Engine Control Module (EMS) Software Information - Improvement List, August 2021 - US17+OBD2019 Emissions ONLY

EMS software improvements with MSW Part Number 23969369/23985827.

Smart Revert High Level Summary

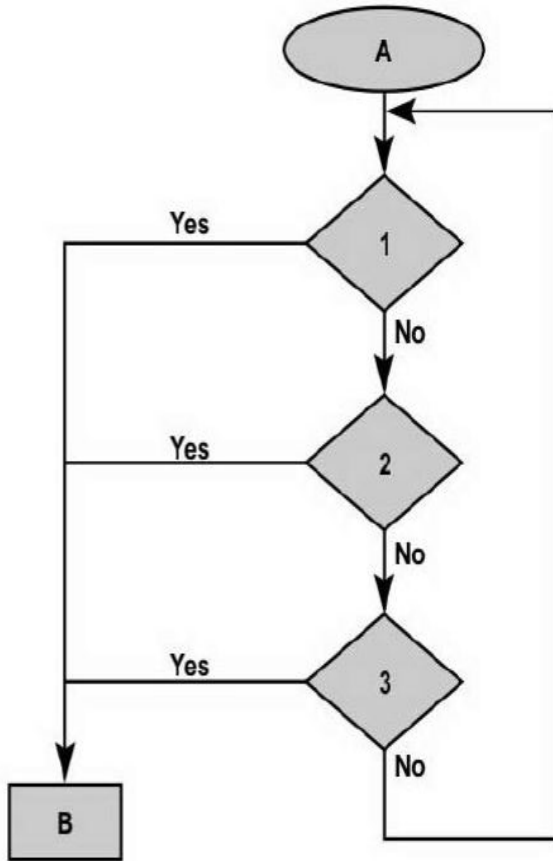
Smart Revert was added to prevent urea doser clogging. Reduces occurrences of clogged urea dosage valve. Smart Revert requires EMS and ACM software for functionality.

DEF Delayed Draining Function	
A	Engine Shutdown/Key Off
1	DEF is at risk of freezing
2	Battery voltage is below 12.2v
3	DEF system waiting state exceeds 17 hours (the maximum time delay)
B	Initiate DEF draining process
